## GEARCASE FAILURES - 75 thru 125

This is a revision of Outboard Service Bulletin 96-17. Destroy existing Bulletin 96-17 and insert revised Bulletin 96-17.

1995, 1996 and 1997 Mercury / Mariner 75 thru 125 HP Models, serial number  
USA 0G077367 thru 0G589999  
BELGIUM 9836633 thru 9973099

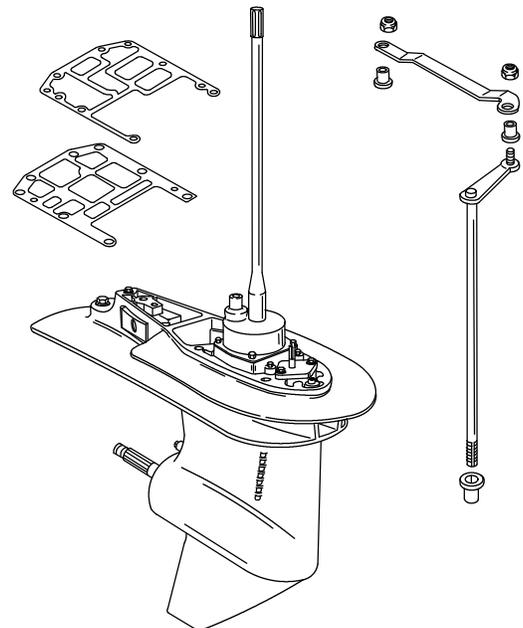
**Jumping Out of Gear** - If the unit will not stay in gear, the clutch dogs are probably rounded off. Inspect the clutch dogs for rounded edges. Rounded clutch dogs are caused by, but not limited to, improper shift cable adjustment, inadequate shift travel, idle rpm too high, and/or shifting too slow. **Rounded clutch dogs are not covered by warranty.**

A gearcase that has been jumping in and out of gear, may have caused the lower shift shaft pivot hole in the gear housing to elongate and not hold the shift cam in the proper position. Reassembly of that gear hous-

ing should NOT be attempted because the identical failure will be repeated in a short period of time. A visual inspection of the lower part of the lower shift shaft pivot hole in the gear housing is almost impossible. **Failure of a reassembled gear housing with an elongated lower shift shaft pivot hole will not be covered under warranty.**

## Shift Cable Installation

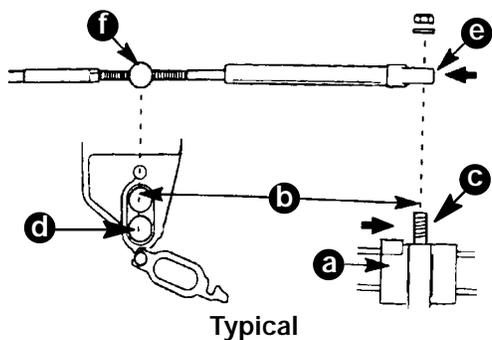
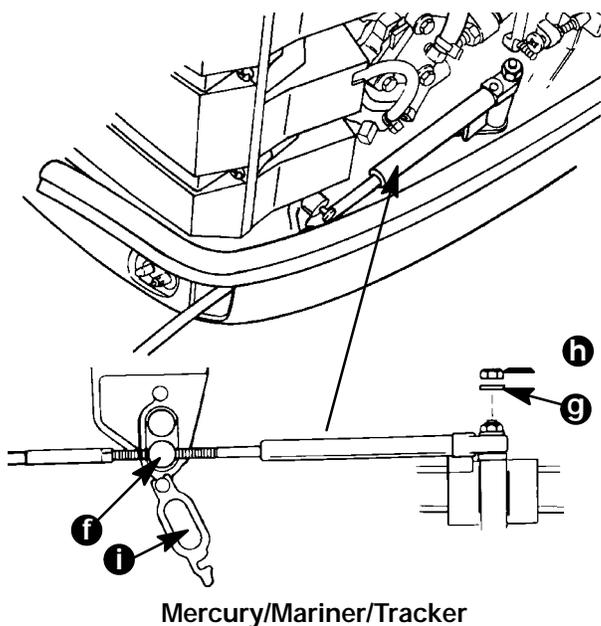
Follow the latest throttle and shift cable adjustment recommendations to ensure gearcase durability.

1. Position the remote control and outboard into neutral.
2. Slide shift actuator (a) toward the rear of engine (reverse gear) until resistance is felt. Measure distance (b) between mounting stud (c) and barrel retainer (d).
3. Push the cable end (e) in (towards cable barrel) until resistance is felt. Adjust the cable barrel (f) to attain distance (b).

4. Place cable barrel (f) into retainer and close latch (i). Fasten the cable end to mounting stud with nylon washer (g) and locknut (h). Tighten locknut against the nylon washer, then back-off the locknut 1/4 turn.

## Recommendation

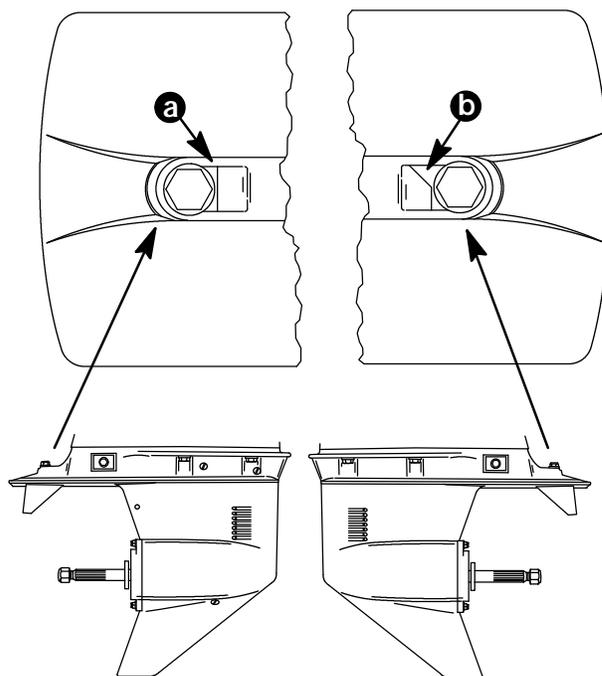
**Commercial applications** should use a propeller with a rubber hub to minimize stress and reduce the possibility of gearcase failures. Order Vengeance, High Five, or Laser II propellers with Flo-Torq I rubber hubs by replacing the "A45" part number suffix with an "A40" suffix.
